# Environmental Impact Statement

Request for Project Change 4

April 2019

**Queensland**  
Government

Figure 3.2: Proposed Changes to CRR Project

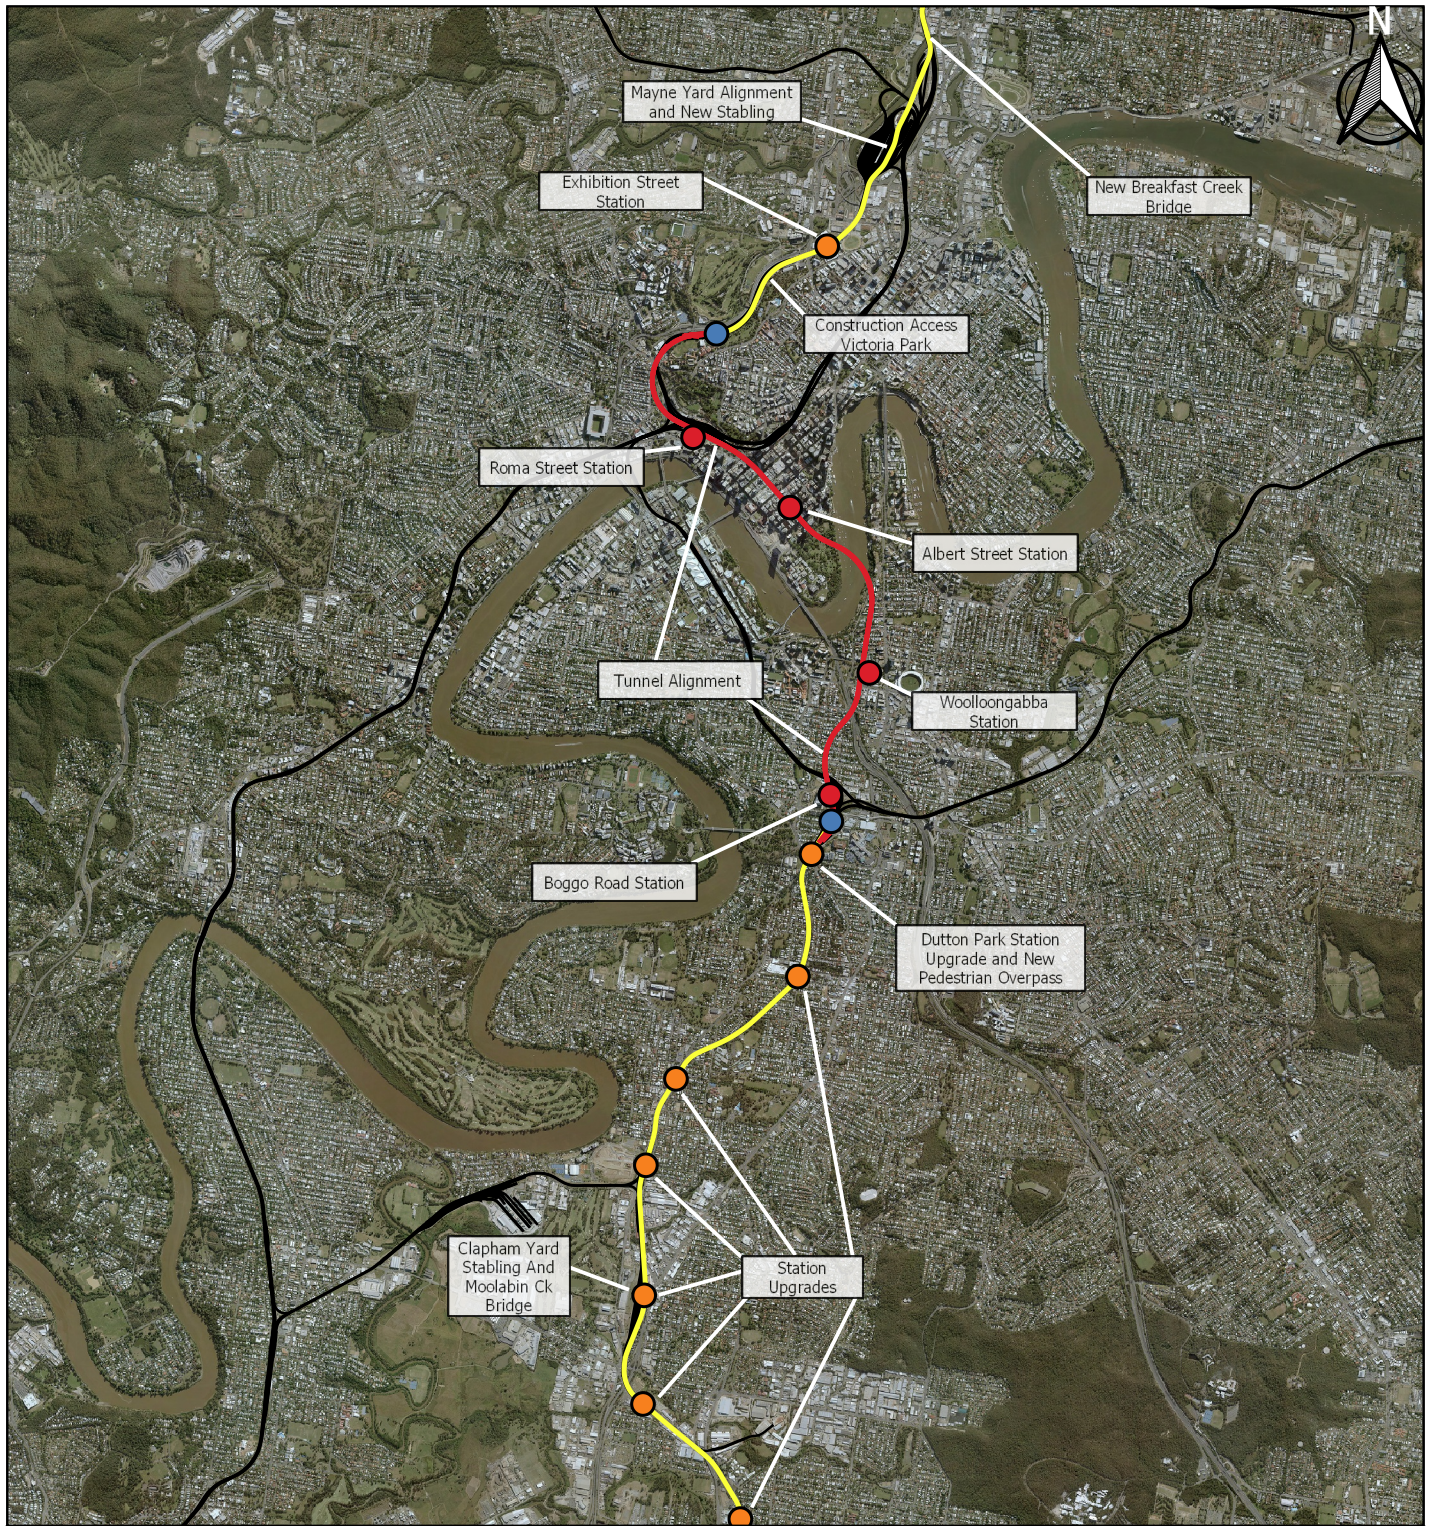
The Proposed Changes are further described within Section 3 of this report and the key changes in each area are illustrated in Figure 3.2.

The Evaluated CRR Project is illustrated in **Figure 3.1** with the key Proposed Changes illustrated in **Figure 3.2** and described in detail in this following section.

Figure 3.3: Mayne Yard Alignment Changes

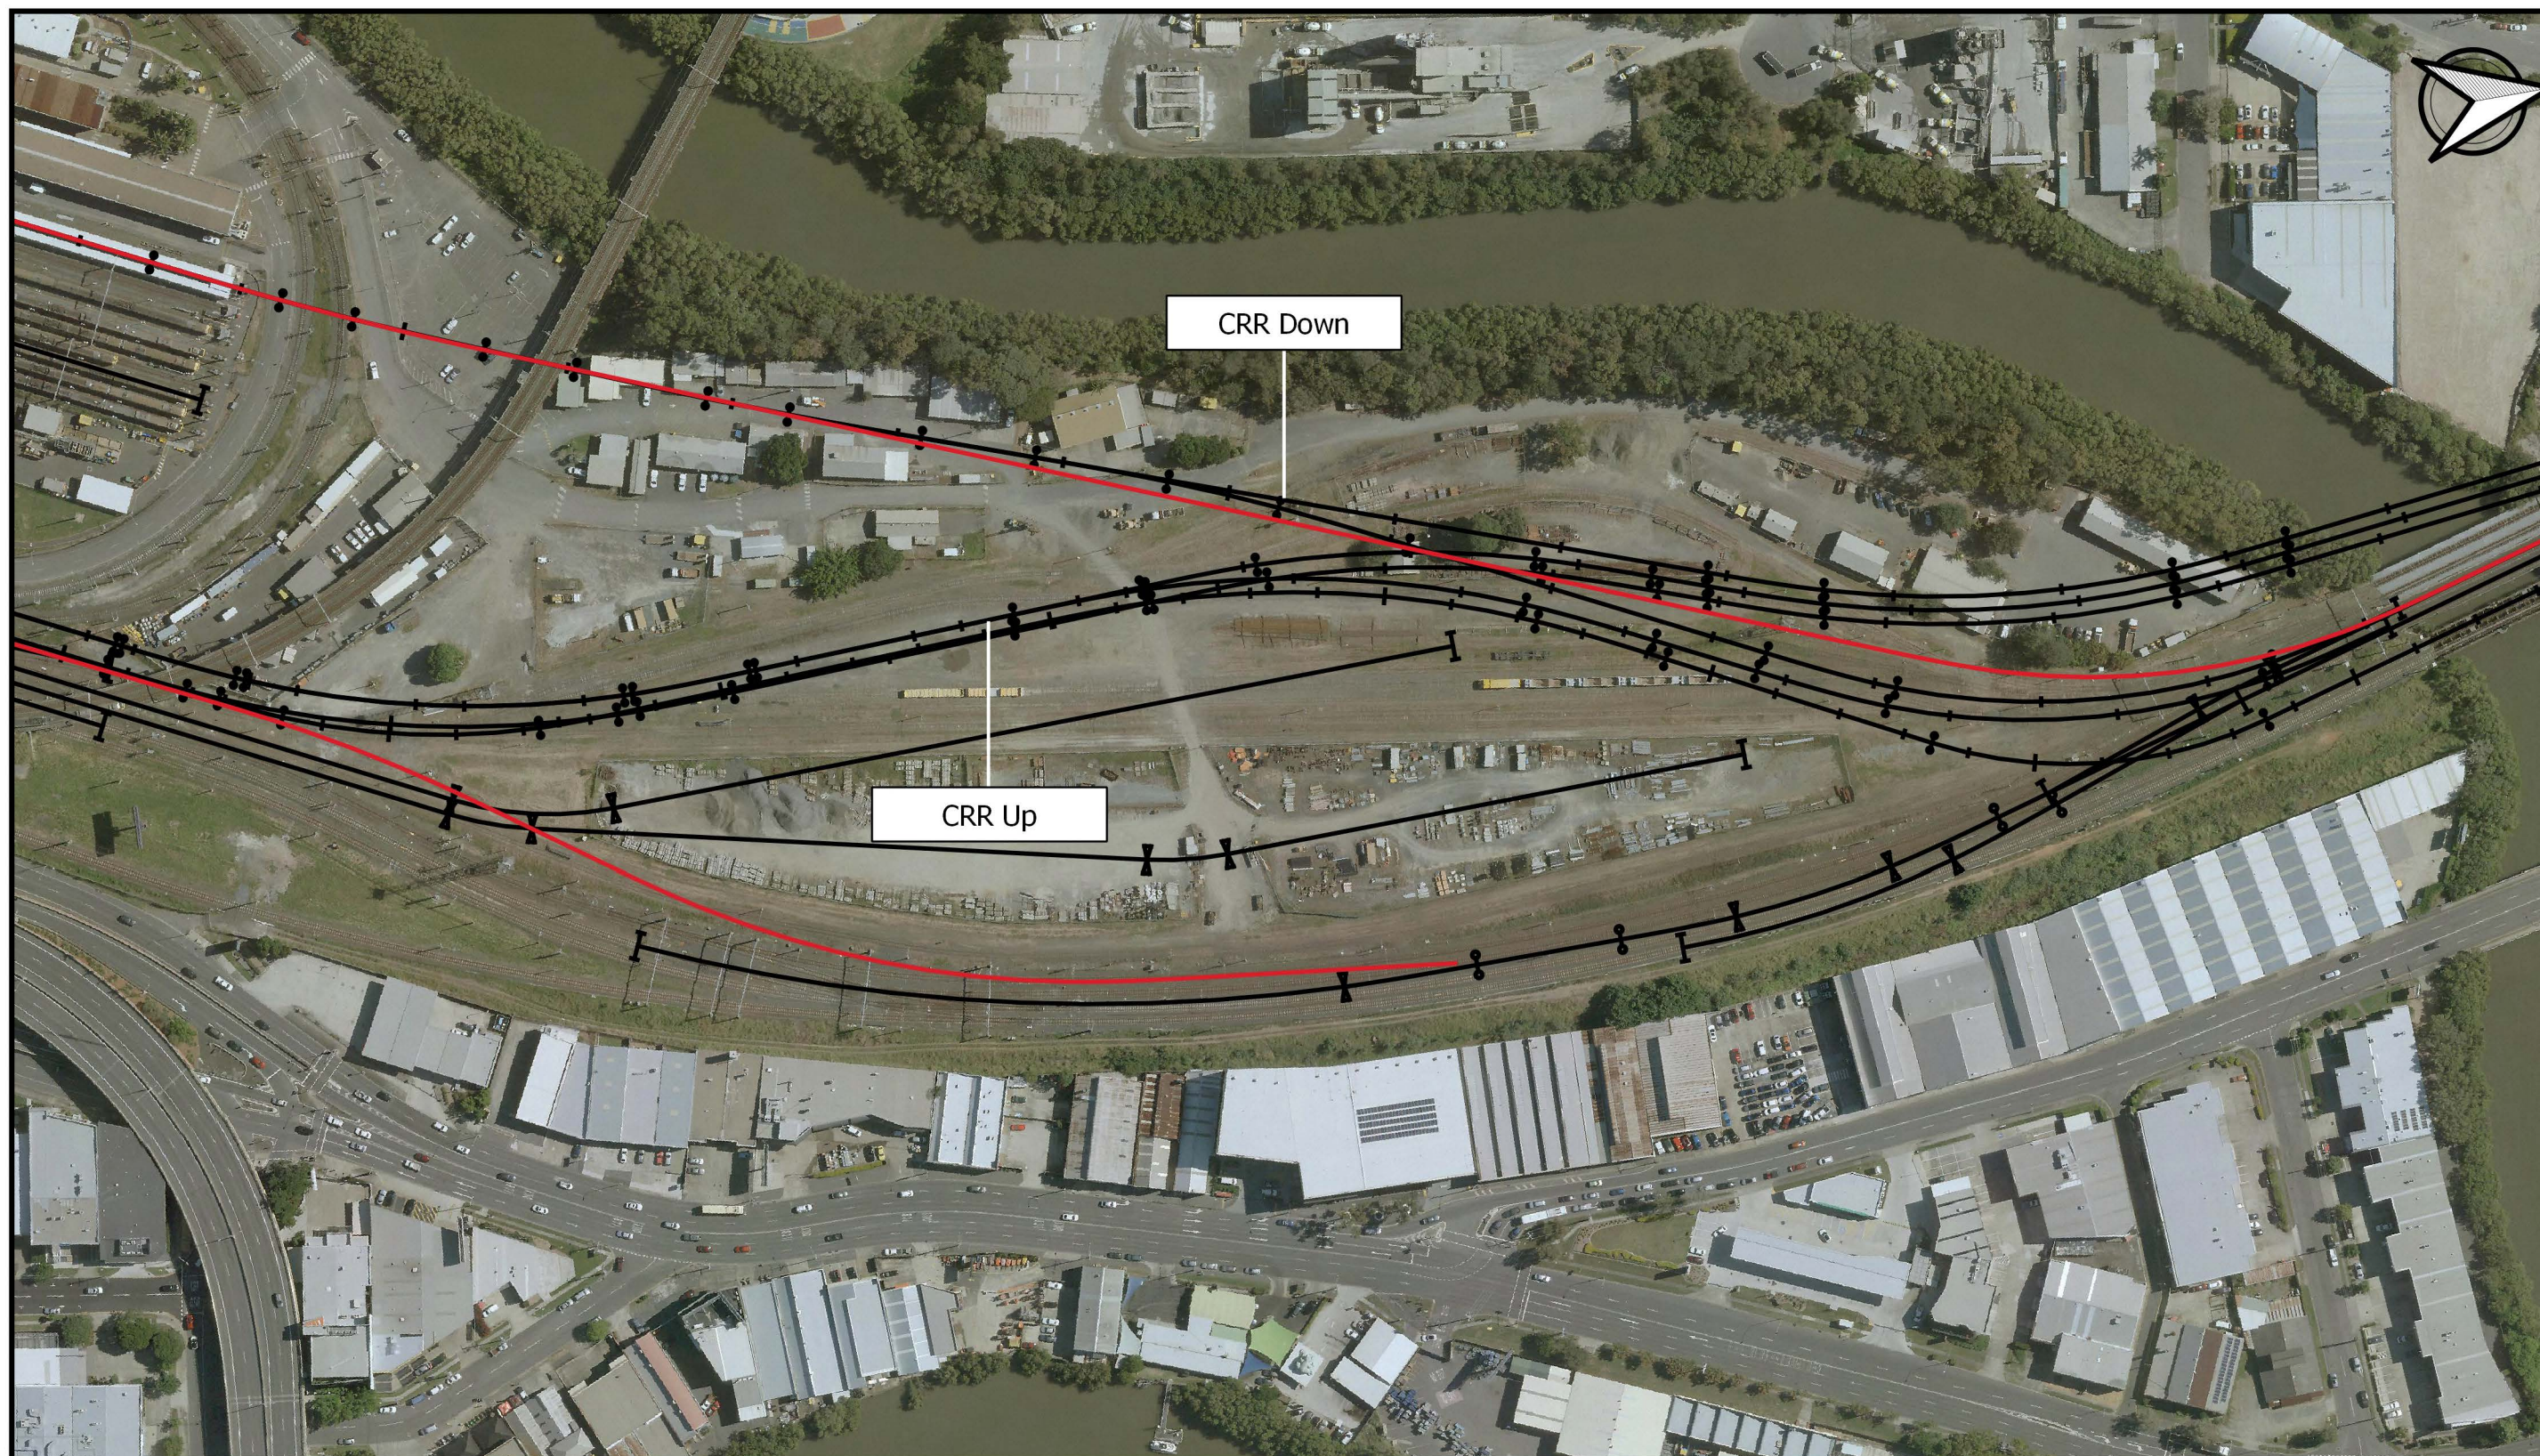
Mayne Yard is the integral stabling and maintenance precinct for QR daily network operations and changes are proposed to avoid impacts from the demolition and relocation of critical QR assets, maximise design speeds and minimise impacts to the existing operational QR network. Figure 3.4 shows the proposed surface rail alignment changes for the Mayne Yard Area. The Proposed Changes are within the existing rail corridor. Key elements of the enhanced geometry include:

- A straighter alignment between the Ferny Grove flyover and Albion overpass for the Up and Down CRR line and the Down Main line;
- The Up and Down CRR and Down Main line cross Breakfast Creek on a new rail bridge approximately 50m west of the existing crossing and tie into the existing curve south of Albion overpass, rather than south of Breakfast Creek; and

- Provision of the small retaining wall between the Main Down and Main Up Crossover connection lines immediately north of Breakfast Creek to address the vertical difference in elevation of the tracks prior to their convergence.

Figure 3.4: Mayne Yard Proposed Changes

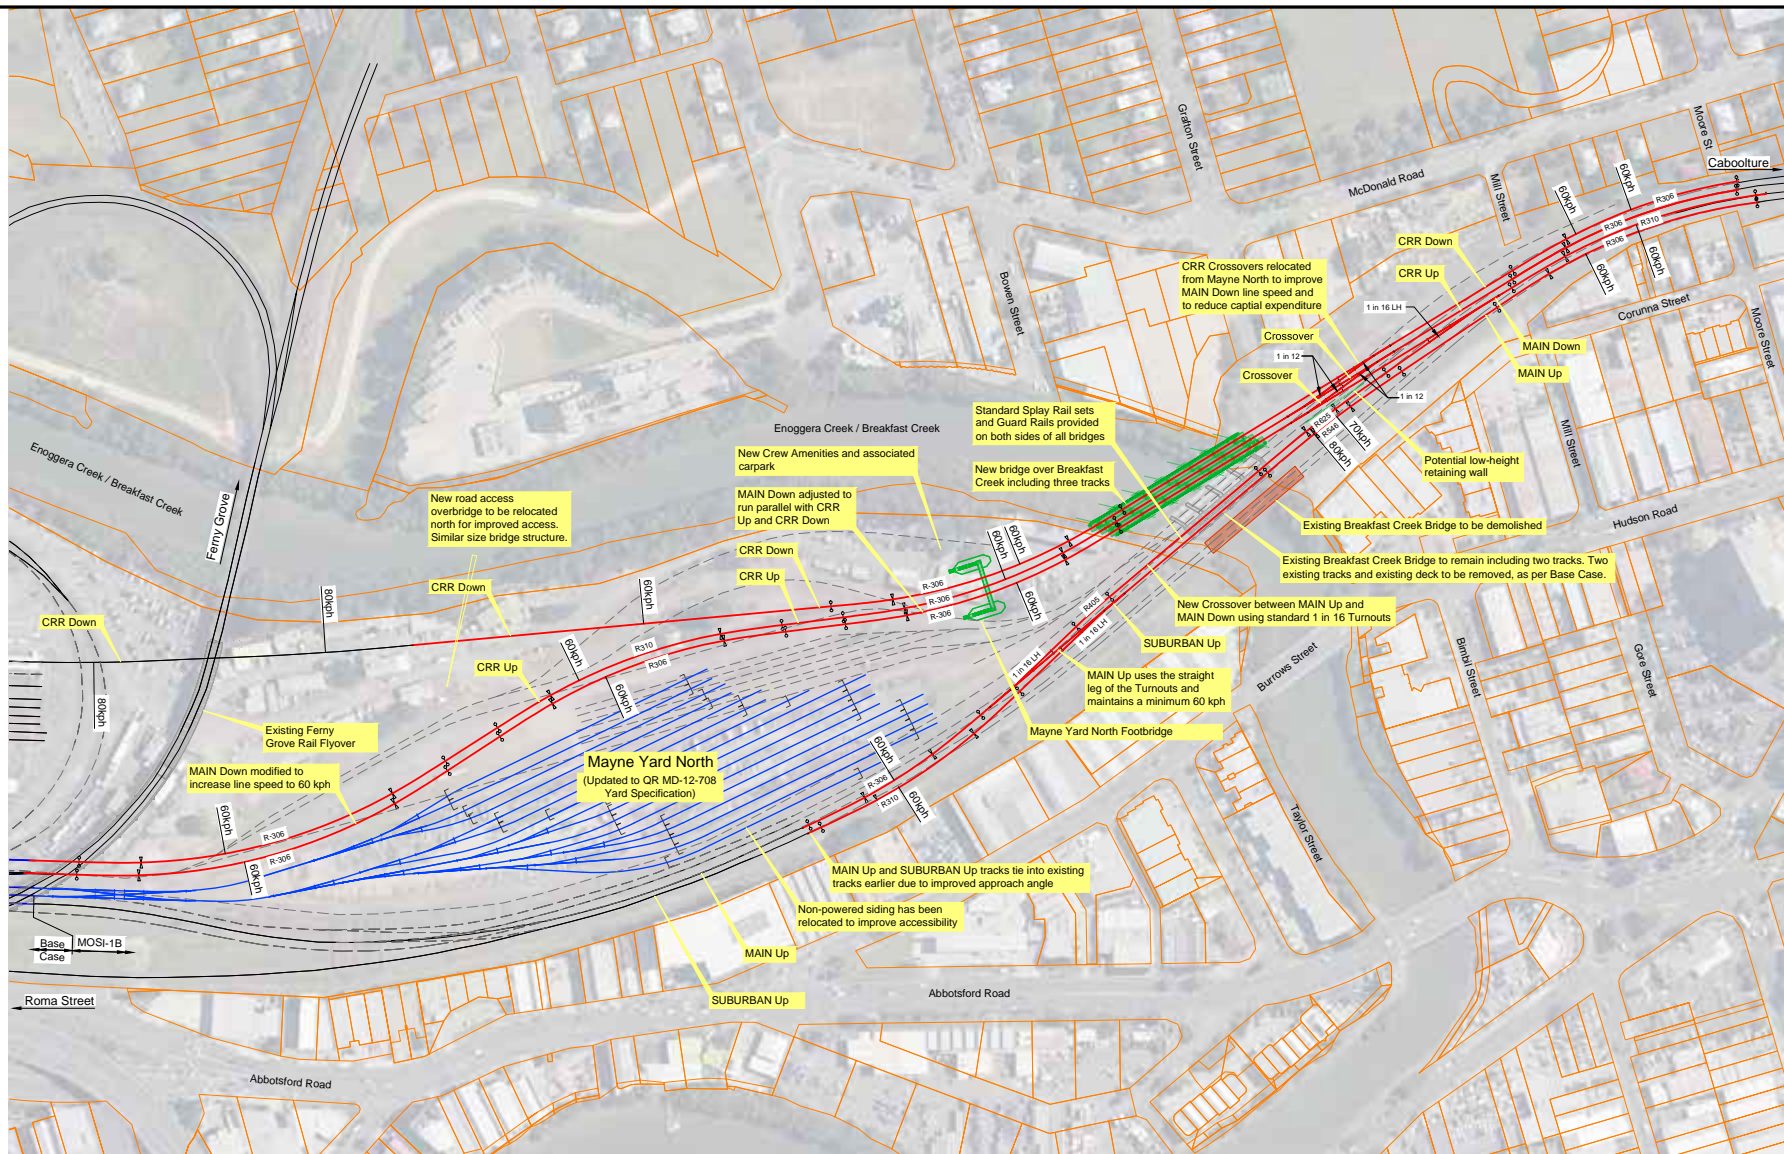
Within the Mayne Yard Area significant engineering and planning has been undertaken to optimise the operational function, minimise the impacts to existing QR operations and achieve main line design speeds of 60 to 80km/hr. Under the Proposed Changes there will be a material increase in the surface works required in the Mayne Yard Area. These works are within in the rail corridor. The key changes include a new Mayne Yard North stabling facility, mainline enhancements which include construction of new overpass bridges for Mayne Yard East and Mayne Yard North access roads and a new bridge over Breakfast Creek, realignment of the Down CRR line and crossovers, a short retaining wall north of Breakfast Creek, and track works to facilitate the changed alignment. These are shown in Figure 3.4 and detailed in Table 3.1.

New construction activities include the new Mayne North Stabling Yard, facility and graffiti removal shed, construction of new overpass bridges for Mayne Yard East and Mayne Yard North access roads, construction of a new bridge structure across Breakfast Creek and track works north of Breakfast Creek. Table 3.1 describes the Proposed Changes from the Evaluated Project associated within Mayne Area.
